Subject: Notification of Class 2 Permit Modification Request to the Waste Isolation Pilot Plant
Hazardous Waste Facility Permit Number: NM4890139088-TSDF

Revise Volatile Organic Compound Monitoring Procedures

**Waste Isolation Pilot Plant
Carlsbad, New Mexico**

WIPP Permit Number - NM4890139088-TSDF

**Figure N-2
VOC Monitoring System Design**

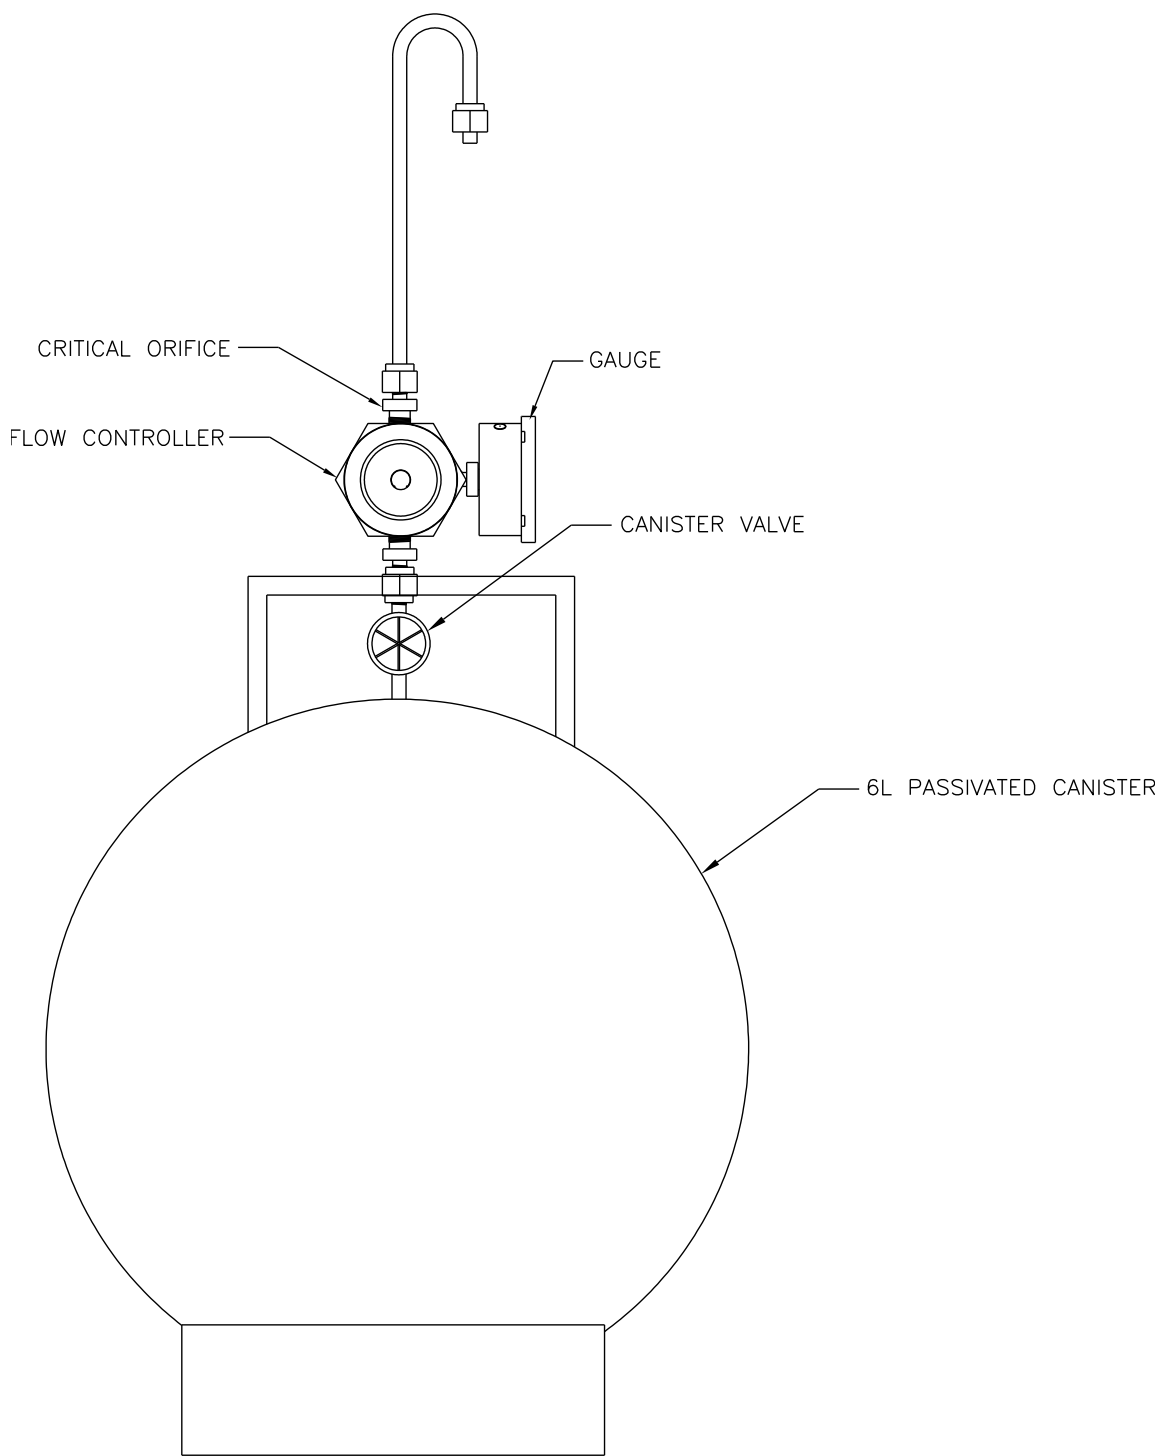
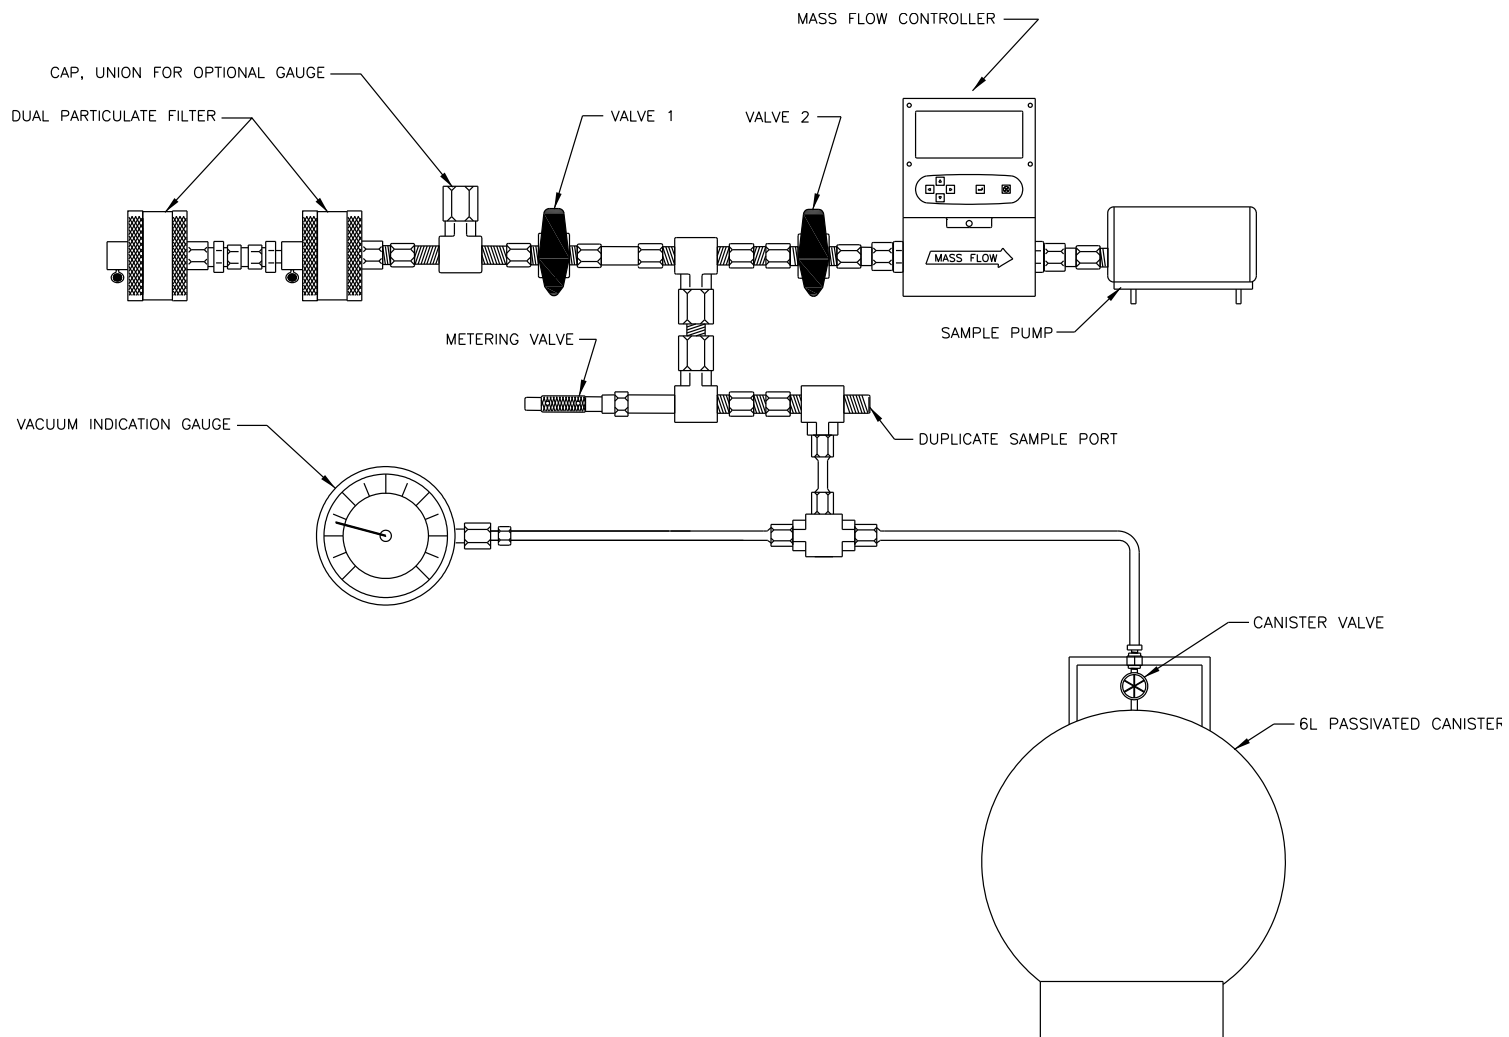
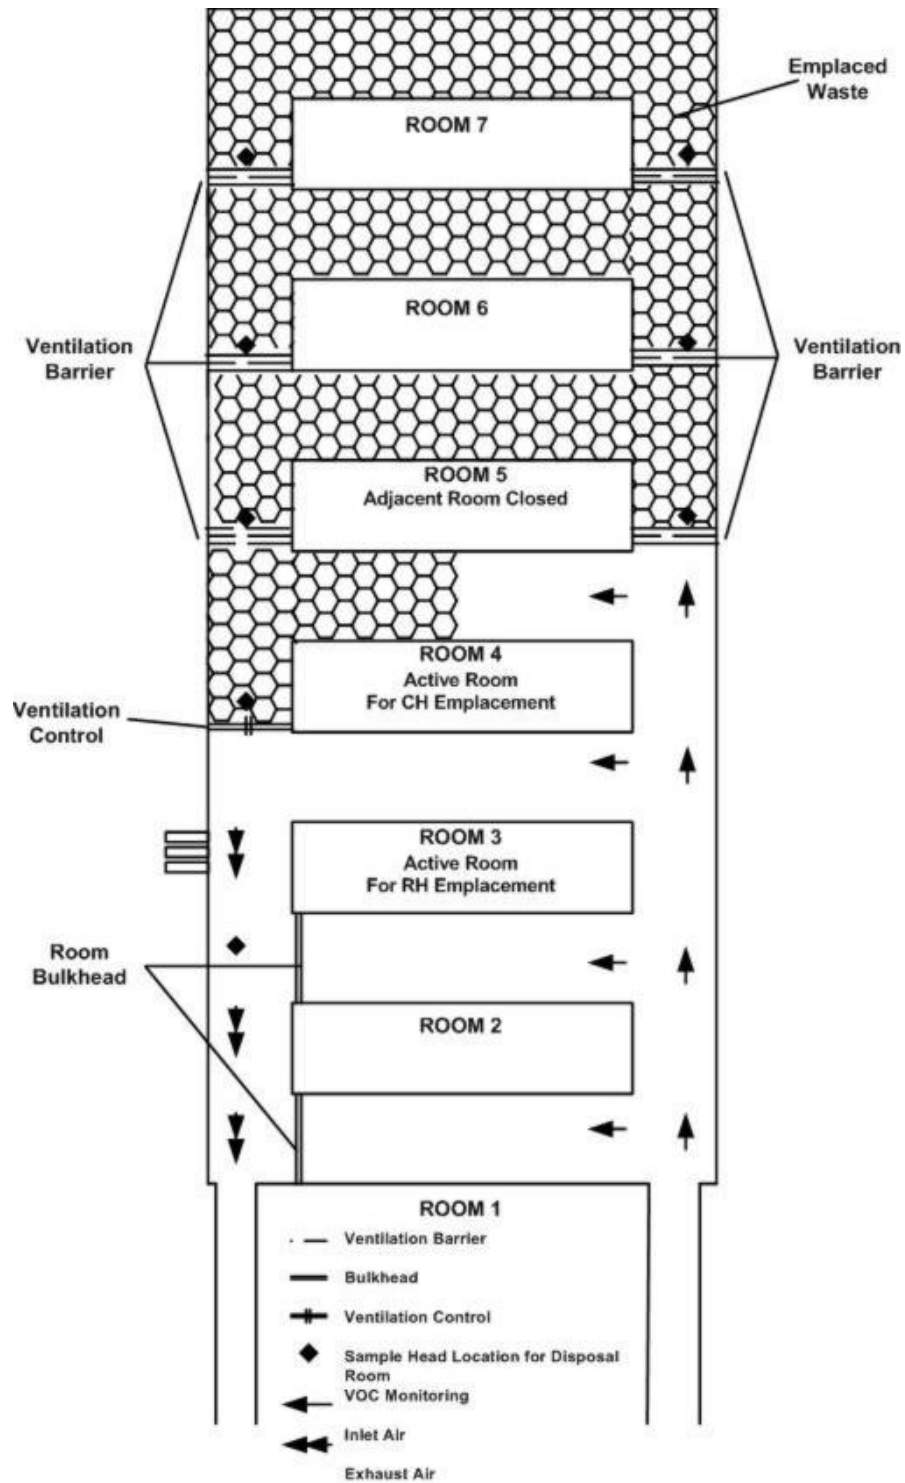
Affected Permit Section	Explanation of Change
	<p>Replaced “A conceptual diagram of the VOC sample collection units are provided in Figure N-2. Such units will be used at monitoring Stations VOC-A and VOC-B and at sampling locations for disposal room measurements. The sampling unit consists of a sample pump, flow controller, sample inlet, inlet filters in series to remove particulate matter, vacuum/pressure gauge, electronic timer, inlet purge vent, two sampling ports, and sufficient collection canisters so that any delays attributed to laboratory turnaround time and canister cleaning and certification will not result in canister shortages. Knowledge of sampler flow rates and duration of sampling will allow calculation of sample volume. The set point flow rate will be verified before and after sample collection from the mass flow indication. Prior to their initial use and annually thereafter, the sample collection units will be tested and certified to demonstrate that they are free of contamination above the reporting limits of the VOC analytical method (see Section N-5). Ultra-high purity humidified zero air will be pumped through the inlet line and sampling unit and collected in previously certified canisters as sampler blanks for analysis. The cleaning and certification procedure is derived from concepts contained in the EPA Compendium Method TO-15 (EPA, 1999).”</p> <p>with</p> <p>“The sample collection unit for surface VOC samples is a commercially available PASK comprised of components that regulate the rate and duration of air flow into a sample canister. It can be operated either manually, using canister valves, or unattended using a programmable timer.</p> <p>The sample collection unit for disposal room VOC monitoring is a subatmospheric sampling assembly that regulates the rate and duration of air flow into a sample canister. The subatmospheric sampling assembly also allows for purging of sample lines to ensure that a representative sample is collected.</p> <p>Sample collection units will use passivated components for the sample flow path. When sample canisters installed on sample collection units are opened to the atmosphere, the differential pressure causes the sample to flow into the canister at a regulated rate. By the end of each sampling period, the canisters will be near atmospheric pressure. Detailed instructions on sample collection will be given in SOPs. A conceptual diagram of a VOC sample collection unit is provided in Figure N-2”</p>

Attachment N, Figures	<p>Replaced Figure N-1 with a new drawing and renamed the title from “Panel Area Flow” to “Repository VOC Monitoring Locations.”</p> <p>Replaced Figure N-2 with a new drawing.</p> <p>Added second page to new Figure N-2.</p> <p>Replaced Figure N-3 with updated drawing and added “Typical” to beginning of the figure title and “Locations” to the end of the title.</p> <p>Replaced Figure N-4 with updated drawing and replaced “VOC” with “Disposal Room” in figure title.</p>
Attachment O, Table of Contents	<p>Deleted entry “O-3b(2) Calculation of the Running Annual Average of Total Mine Airflow” section is being deleted.</p> <p>Deleted “Running Annual Average of the.”</p>
Attachment O, Section O-2	<p>Deleted first bullet “Maintaining an annual running average of 260,000 scfm through the underground repository”</p>
Attachment O, Section O-3	<p>Deleted second bullet “Monitoring and calculation of the Running Annual Average of the Total Mine Airflow to verify achievement of the 260,000 scfm minimum</p>
